## COMMENT SHEET

### Environmental Impact Statement and Overseas Environmental Impact Statement Guam and CNMI Military Relocation

**Figure 1.** Transect locations from Campora and Lee (2009) overlaid onto map of Anderson South and Route 15 lands from the DEIS (Volume 2, Chapter 10, Figure 10.2.11, Page 10-111)

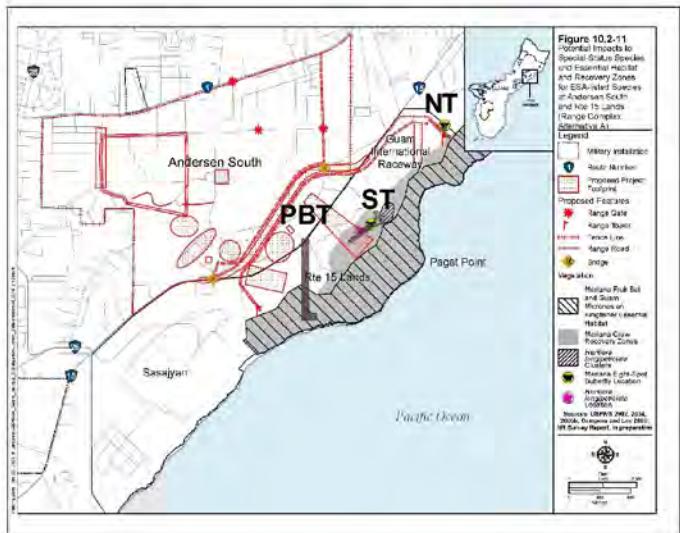
- The transects covered only a minute proportion of the Route 15 lands (See Figure 1 in this document)
  - The North transect extended onto the footprint of the proposed project by only a few meters, and only on one day, July 15, 2009 (See Figure 2 in this document)
